**PLANNED UNIT DEVELOPMENT  
STAFF REPORT****Date: July 21, 2016****NAME**

Volunteers of America

**NAME**6500 Zeigler Boulevard  
(North side of Zeigler Boulevard, 150'± East of Athey Road, extending to the East side of Athey Road, 150'± North of Zeigler Boulevard)**CITY COUNCIL  
DISTRICT**

Planned Unit Development Approval to amend a previously approved Planned Unit Development to allow multiple buildings on a single building site.

SITE PLAN

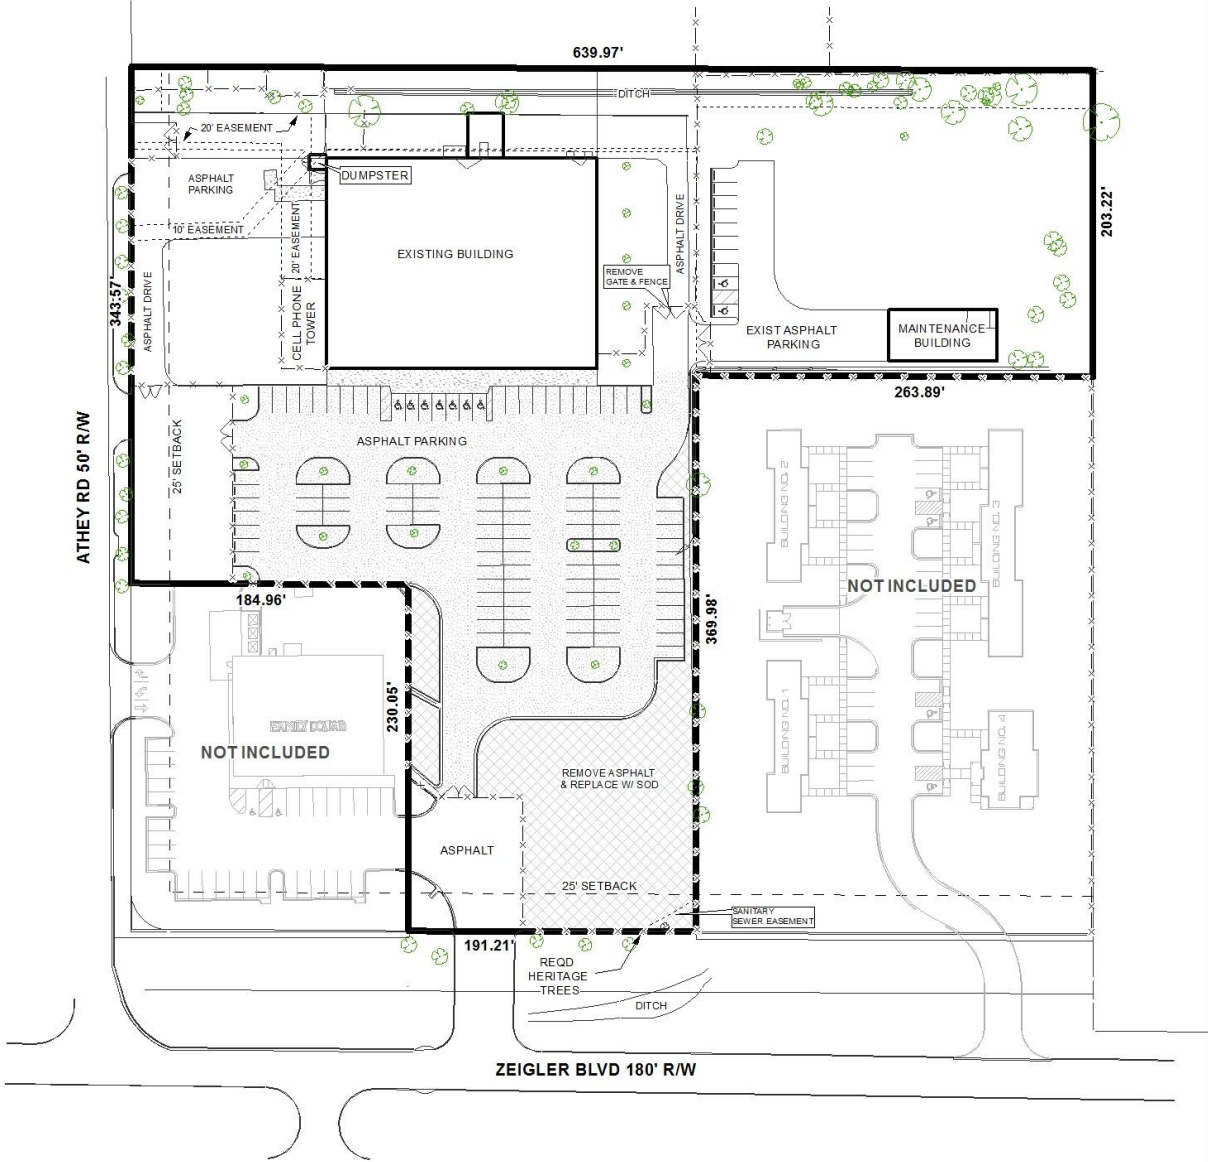
It appears that the parking stall dimensions and the access aisle widths reflect compliance with Section 64-6.A.2. of the Zoning Ordinance; however, some parking spaces are not clearly delineated due to the interference of text labels. The site plan should be revised to clearly depict each onsite parking space.

The site plan illustrates fencing at the front property line along Zeigler Boulevard and Athey Road, in addition to the remaining perimeter of the property; however, the fence type and height is not indicated on the site plan. According to Section 64-4.D.6.a. of the Zoning Ordinance, *“no fence or wall that obstructs sight shall be erected or altered in any required front yard to exceed a height of three (3) feet, and no fence or wall shall be erected or altered in any required side or rear yard to exceed a height of eight (8) feet.”* The site plan should be revised to indicate the proposed fence type and height to be erected on the subject lot, particularly the portions located at the front property line along Zeigler Boulevard and Athey Road, and should ensure that the fencing is compliant with the requirements of the Zoning Ordinance prior to the issuance of any building permits.

Being that the site will have gated access points along both Zeigler Boulevard and Athey Road, the applicant should make certain that the width and length of the queuing spaces at each gated access point are in compliance with Section 64-4.F.2.a. of the Zoning Ordinance. The ingress/egress lane shall provide a minimum of three (3) queuing spaces of not less than 60 feet from the street right-of-way to the gated fence entry, especially if the gates are to remain closed during normal business operating hours. The queuing spaces along the primary access points at both Zeigler Boulevard and Athey Road are illustrated as 89'± and 68'± from the right-of-way,

thus reflecting compliance with Zoning Ordinance requirements. However, a secondary access point located to the far northwestern portion of the subject site, approximately 150'± North of the primary entrance along Athey Road, only depicts a queuing length of 30'. The site plan should be revised to depict a minimum of three (3) queuing spaces of not less than 60 feet from the street right-of-way to the gated fence.

Note #1 on the site plan says "Type of Survey: Administrative P.U.D.", and needs to be revised to state "P.U.D." and not "Administrative P.U.D.," as this request requires the approval of the Planning Commission and not staff.

- 1) Revision of the site plan to clearly depict each onsite parking space;
- 2) Revision of the site plan to indicate the proposed fence type and height prior to the issuance of any building permits;
- 3) Revision of the site plan to depict a minimum of three (3) queuing spaces of not less than 60 feet from the street right-of-way to the gated fence;
- 4) Revision of Note #1 on the site plan to state "P.U.D." and not "Administrative P.U.D.";
